Section 75W Modification Application
Environmental Assessment Report

Edmondson Park South Concept Plan (MP10_0118)

Prepared for Urban Property Group

Figure 2 Landcom Town Centre North Precincts

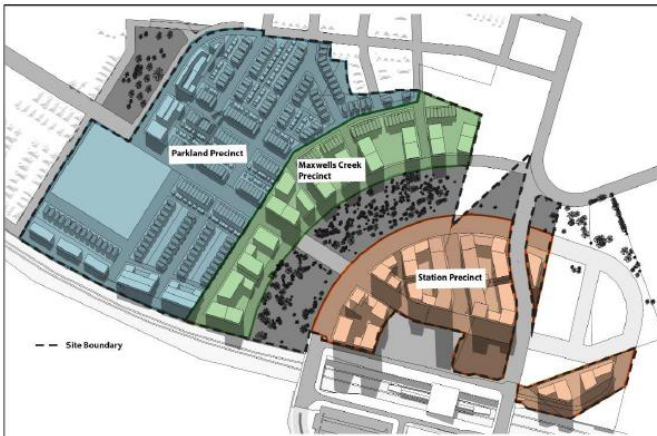
To reflect the removal of 4–5, 6–7 and 8 Buchan Avenue, Edmondson Park (Lots 4, 5, 6 and 7 in DP1275478) from the Concept Plan boundary, revised mapping for the Edmondson Park Town Centre North Precinct has been prepared by Beam Planning.

The updated mapping provides a consistent representation of the amended Concept Plan area and ensures that all graphical documentation aligns with the proposed boundary adjustment. The revised figures include the following:

The revised maps have been appended to this report at **Appendix A** and will supersede those currently approved under Mod 5 for consistency.
